The Commission has issued the enclosed Amendment Nos. 110 and 93 to Facility Operating License Nos. DPR-53 and DPR-69 for Calvert Cliffs Nuclear Power Plant, Unit Nos. 1 and 2. These amendments consist of changes to the Technical Specifications in response to your application dated November 1, 1985.

The amendments change the Calvert Cliffs Units 1 and 2 Technical Specifications (TS) as follows: (1) TS 6.2.1 and 6.2.2, "Organization", are revised via TS Figures 6.2-1 and 6.2-2 to reflect an extensive corporate reorganization; (2) the titles of a number of individuals, as reflected in TS Section 6.0, "Administrative Controls", are changed as a result of the reorganization; and (3) TS 6.5.1, "Plant Operations and Safety Review Committee (POSRC)", is changed to reflect the elimination of one member from the POSRC.

Amendment No. 110
License No. DPR-53

Amendment No. 93
License No. DPR-69

FIGURE 6.2-1
 MANAGEMENT ORGANIZATION CHART
 CALVERT CLIFFS NUCLEAR POWER PLANT
 BALTIMORE GAS & ELECTRIC COMPANY

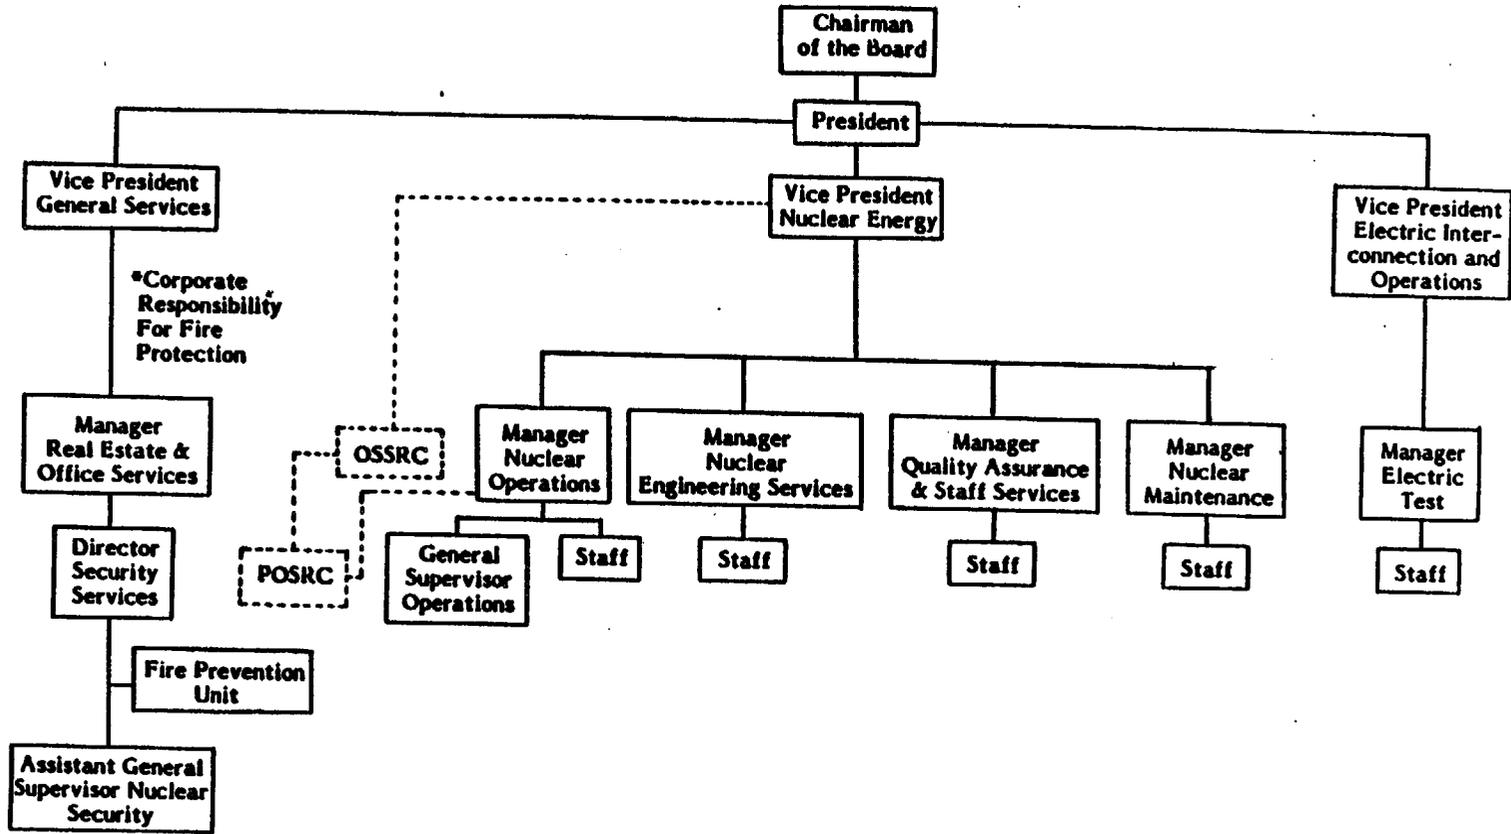
6.2.1 The offsite organization for facility management and technical support shall be as shown on Figure 6.2-1.

The reorganization proposed by BG&E represents a significant change in the off-site and on-site organizational structure as reflected in TS 6.2.1 and 6.2.2, respectively. The Vice President-Supply and Vice President-Engineering and Construction positions would be eliminated. A new position of Vice President-Nuclear Energy would be created which would encompass the present responsibilities of the above two eliminated positions with respect to BG&E's nuclear program. Reporting to the Vice President-Nuclear Energy would be four managers: Manager-Nuclear Operations (The Manager-Nuclear Operations would assume the current responsibilities of the Plant Superintendent with respect to nuclear safety); Manager-Nuclear Engineering Services (The Manager-Nuclear Engineering Services would be established to consolidate all of the engineering support staff into a single department); Manager-Quality Assurance and Staff Services (The Manager-Quality Assurance and Staff Services would assume the responsibilities of the present Manager-Quality Assurance with exception of the Quality Control function); and Manager-Nuclear Maintenance (The Manager-Nuclear Maintenance would be responsible for the electrical, instrument, and control, and mechanical maintenance/modification crafts and technicians and their associated quality control inspectors.)

FIGURE 6.2-2
 ORGANIZATION CHART (TWO UNIT OPERATION)
 CALVERT CLIFFS NUCLEAR POWER PLANT
 BALTIMORE GAS & ELECTRIC COMPANY

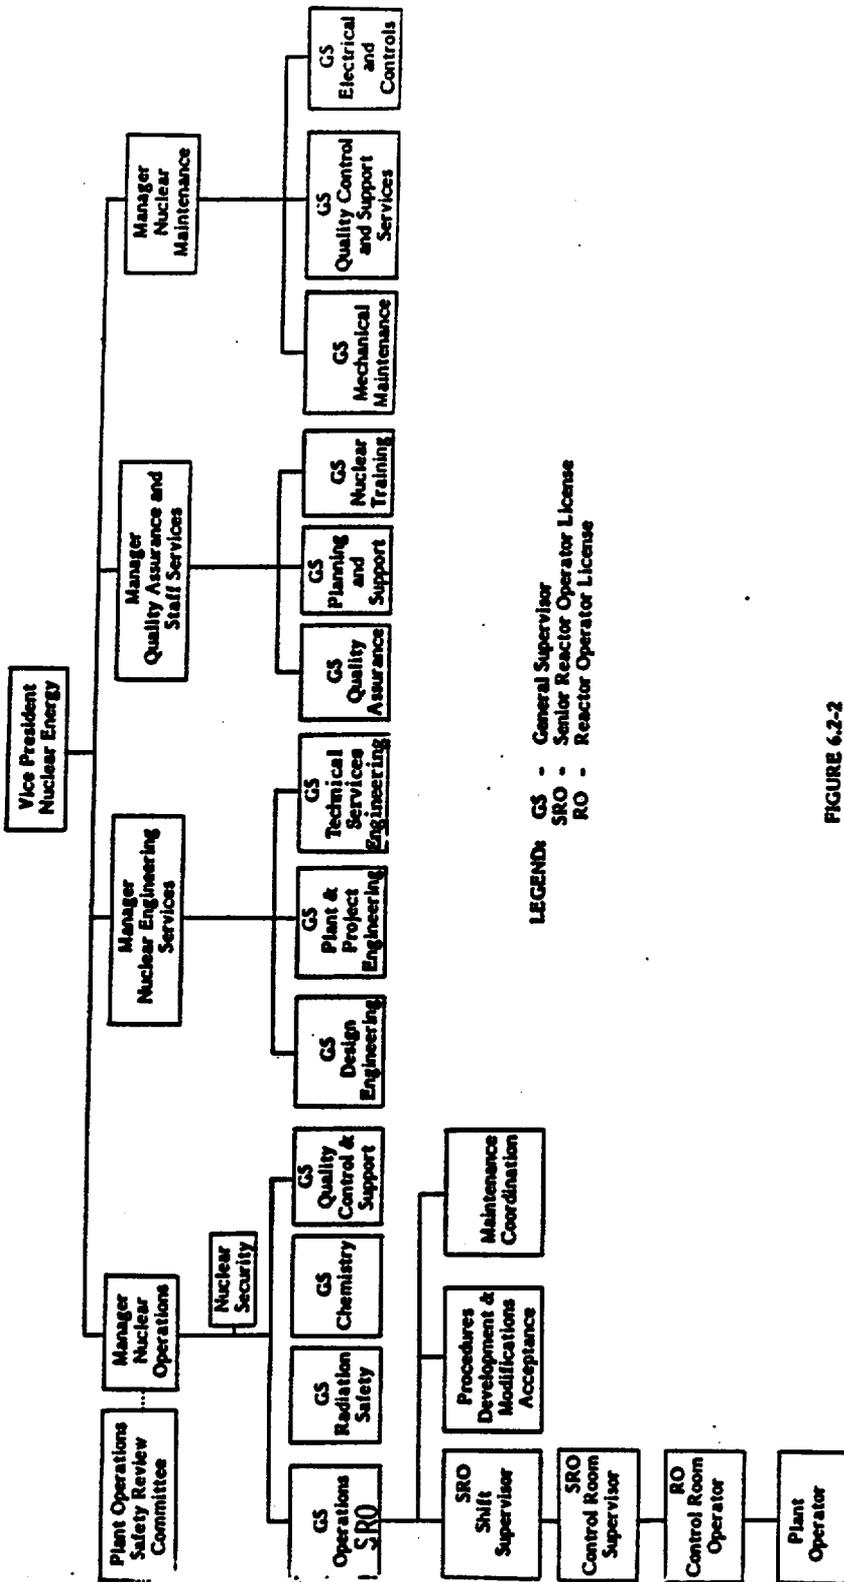
6.2.2 The Facility organization shall be as shown on Figure 6.2-2 and:

FIGURE 6.2-1
MANAGEMENT ORGANIZATION CHART
CALVERT CLIFFS NUCLEAR POWER PLANT
BALTIMORE GAS & ELECTRIC COMPANY

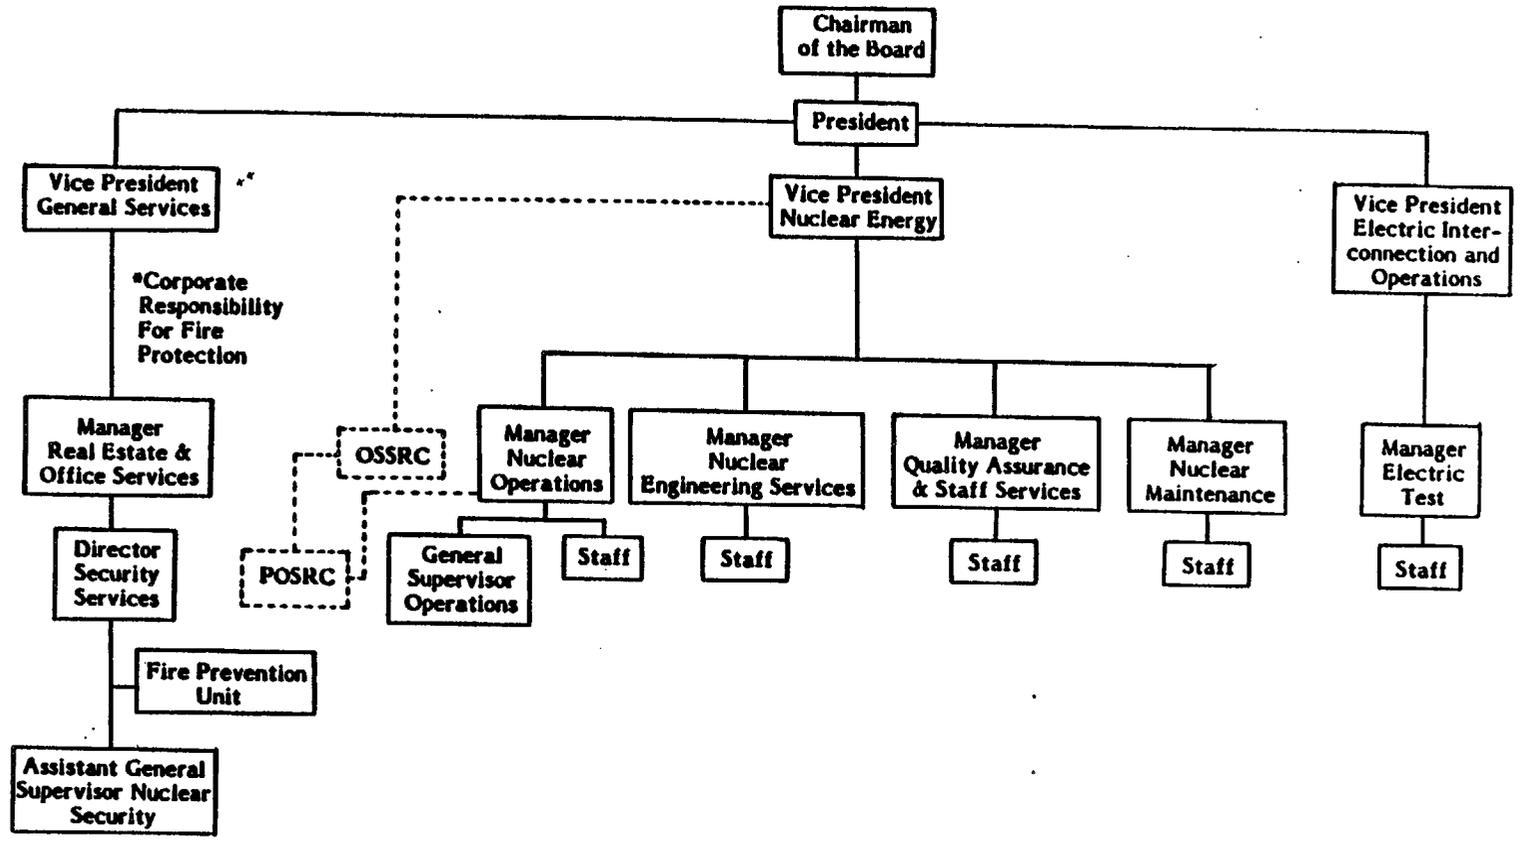
6.2.1 The offsite organization for facility management and technical support shall be as shown on Figure 6.2-1.

FIGURE 6.2-2
 ORGANIZATION CHART (TWO UNIT OPERATION)
 CALVERT CLIFFS NUCLEAR POWER PLANT
 BALTIMORE GAS & ELECTRIC COMPANY

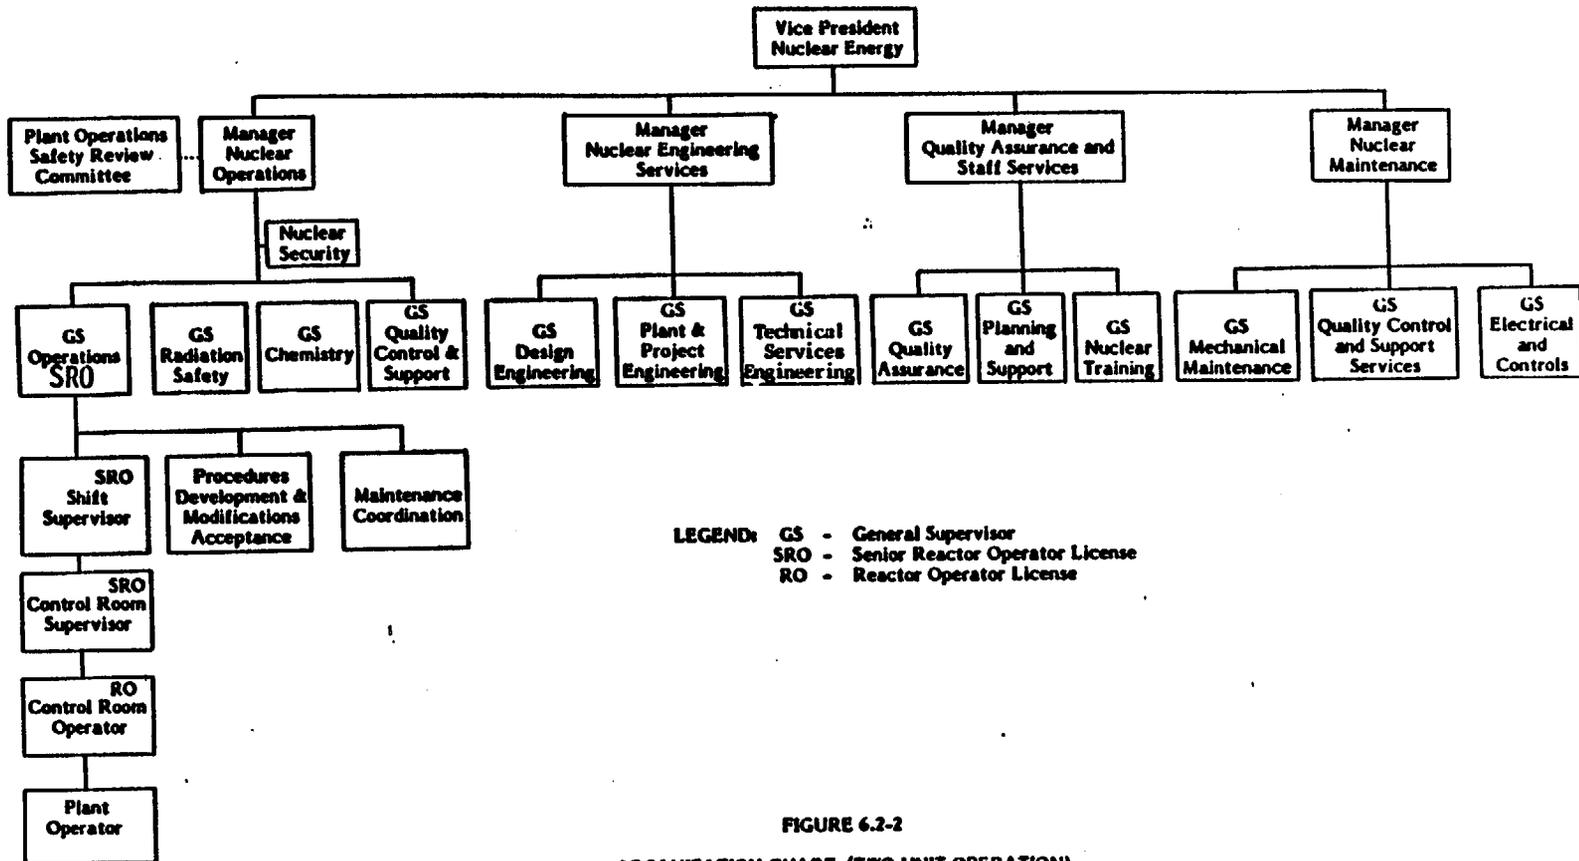
6.2.2 The Facility organization shall be as shown on Figure 6.2-2 and:
